RE: MAXWELL PROJECT (SSD-9526) – RESPONSE TO INFORMATION REQUEST

I refer to the Department of Planning, Industry and Environment's information request (dated 30 March 2020). The matters raised in the Department's information request are addressed in the enclosures to this letter, as summarised below.

RE: Maxwell Project – Air Quality and Greenhouse Gas Assessment – Request for Additional Information

Figure E-21: Predicted maximum 24-hour average PM_{2.5} concentrations due to emissions from the Project in Scenario 3 ($\mu\text{g}/\text{m}^3$)

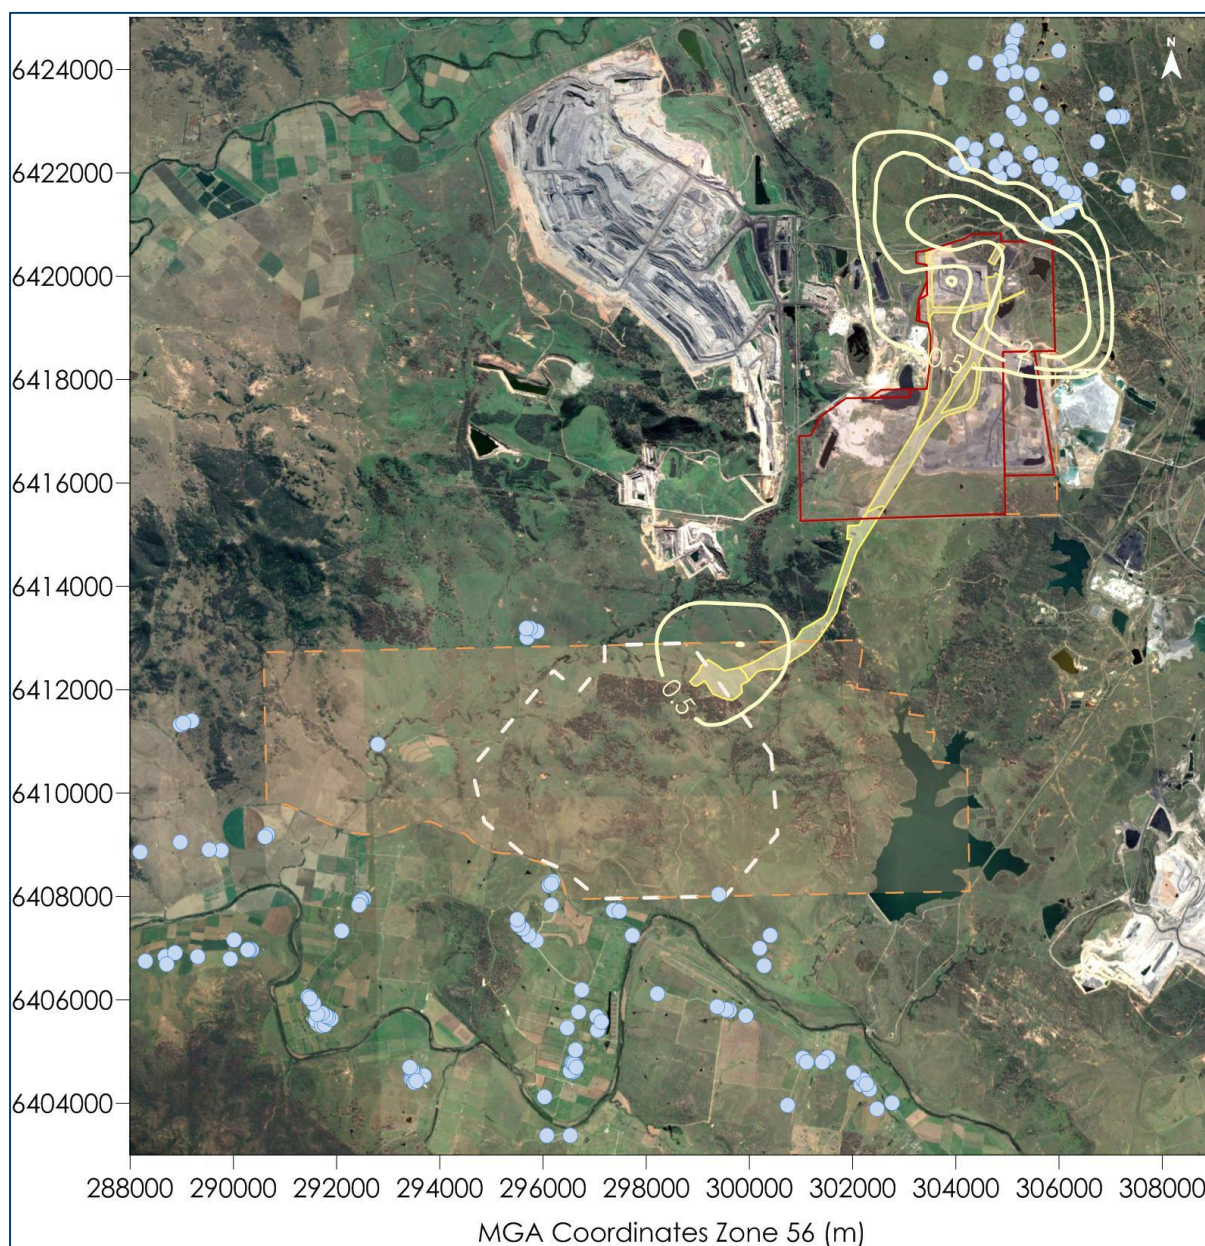
- *Please provide high-resolution versions of Figures E-21, E-23, E-24 and E-26 from Appendix J of the EIS. Please include receiver numbers for the receivers closest to the Maxwell Underground and Maxwell Infrastructure sites on these figures.*

Please see below higher-resolution versions of Figures E-21, E-23, E-24 and E-26 from Appendix J of the Air Quality Assessment.

Due to the large number of clustered receptors, it is not practical to clearly show the receiver numbers on even these high resolution figures.

However, review of Figures E-21, E-23, E-24 and E-26 indicates that contours are only close to privately-owned receptors on Figures E-21 and E-24, in the area to the north-east of the Maxwell Infrastructure. As such, please refer to “zoomed in” versions of these figures, showing the individual receptor numbers, presented as **Figure 1** (i.e. E-21) and **Figure 2** (i.e. E-24) below.

Figure 2

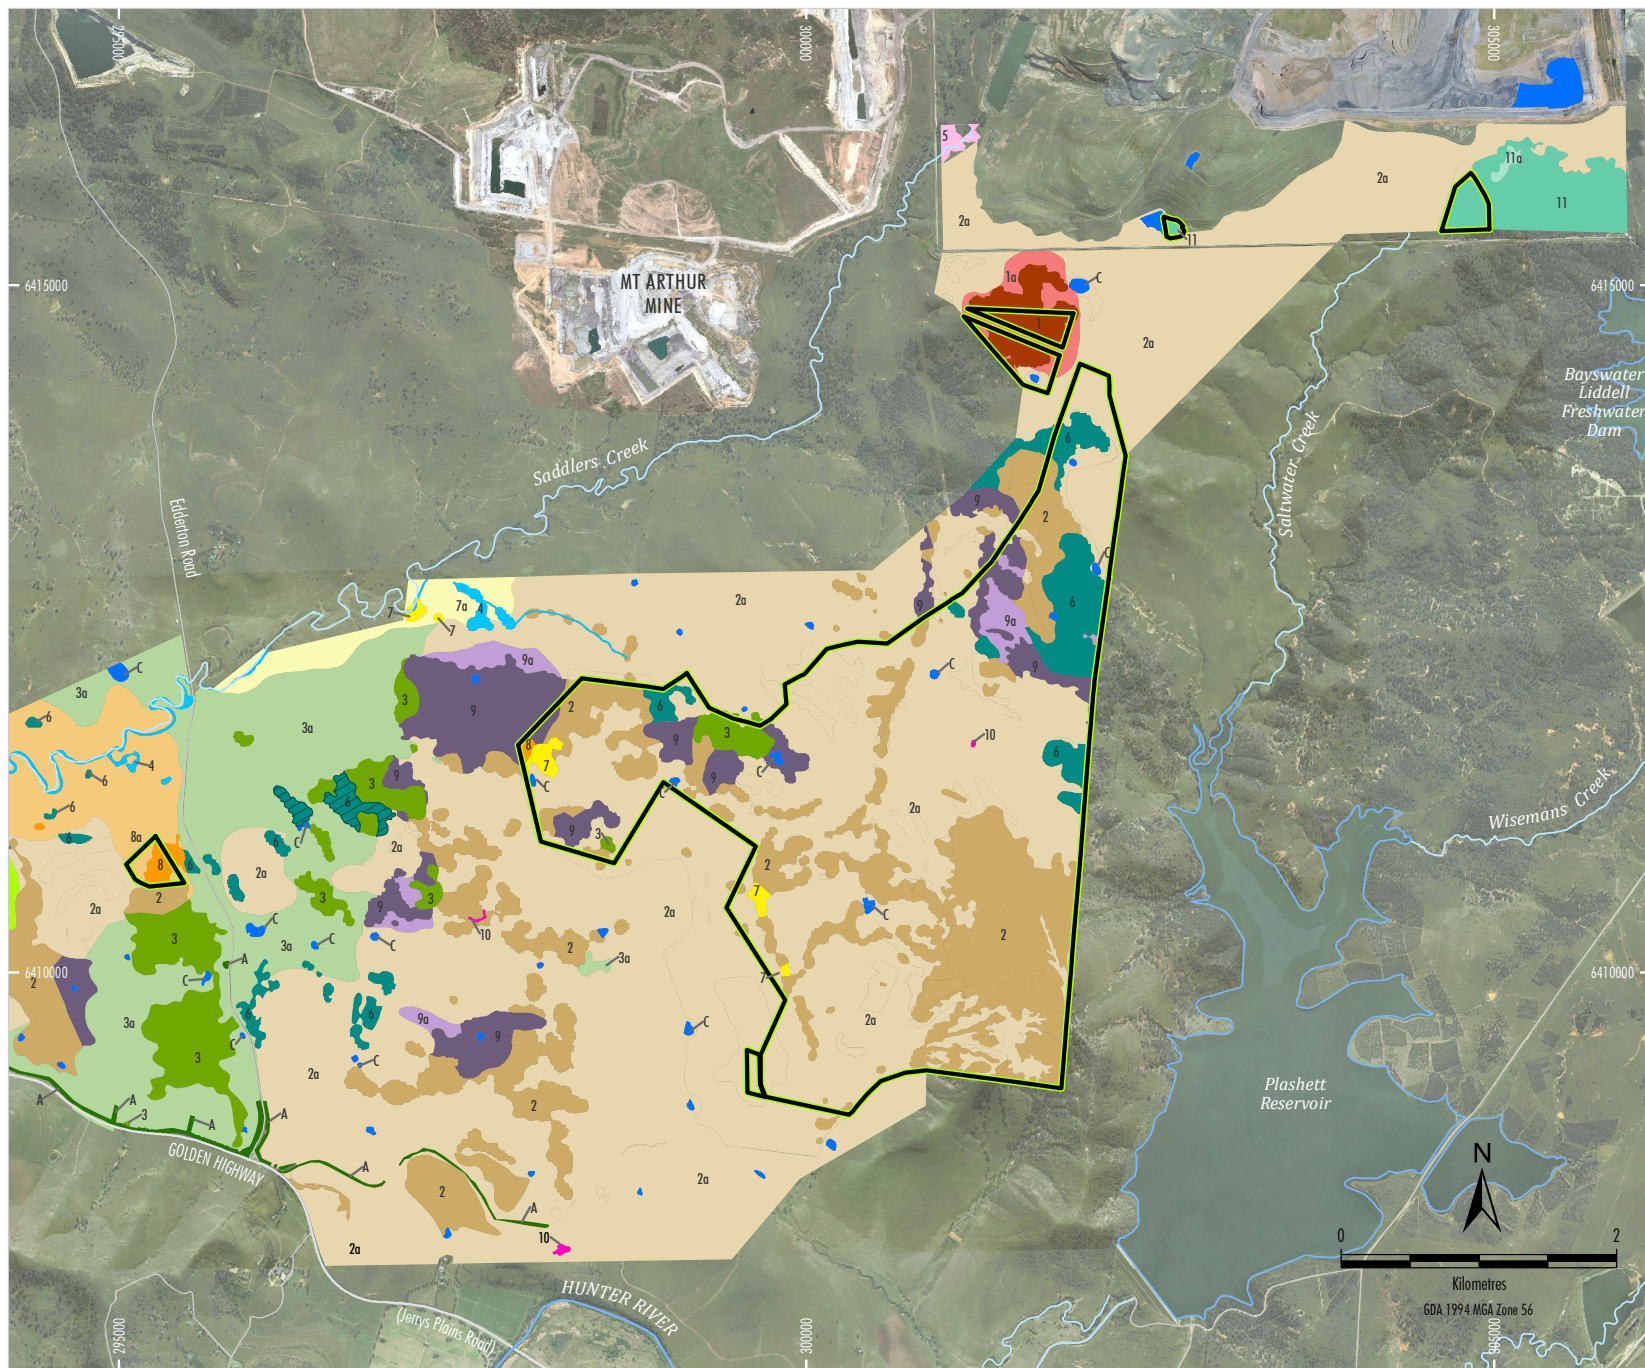
Having the applicant identifying and securing locally sourced offsets is the most desirable outcome as it gives a more transparent and certain conservation outcome to the development application.

Malabar has subsequently commissioned additional biodiversity surveys in the vicinity of the Project to ascertain the suitability of the land for offsets. Floristic plot data have been collected in accordance with the BAM and targeted surveys for Pink-tailed Legless Lizard habitat have been undertaken. As a result of these additional works, a suitable land-based offset has been identified in the vicinity of the Project (Figure 2).
